Architect's Supplemental Instructions

Architect's ASI No: 052

Project:
Webster University
Interdisciplinary Science
Building

Description: ASI – 052

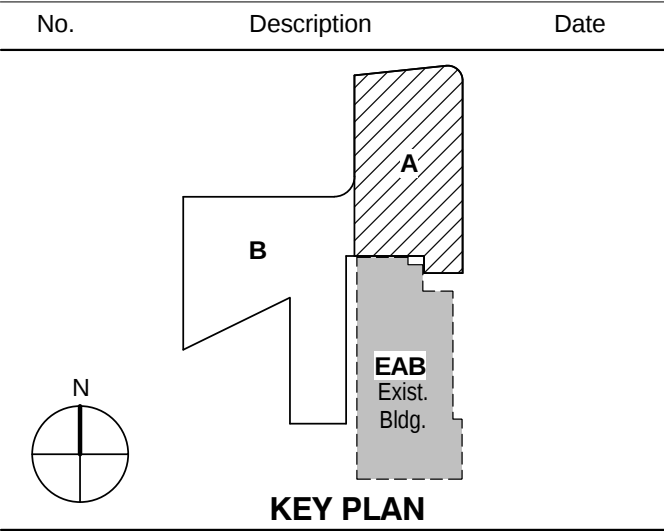
ASI-052 is being issue for the purpose of addressing the relocation of a wall hydrant on the east wall.

ASI-052, (P0101.A & P0403); Relocate wall hydrant on east wall from north of Column Line "D" to a new location north of Column Line E, north of the double door entrance to the Fire Pump Room 186. Provide service to new hydrant location by re-routing ¾" cold water line off of the north end of the proposed 3 inch water service located between Column D and Column E and west of Column 8. Refer to sheet P0403 Riser – Plumbing for changes.
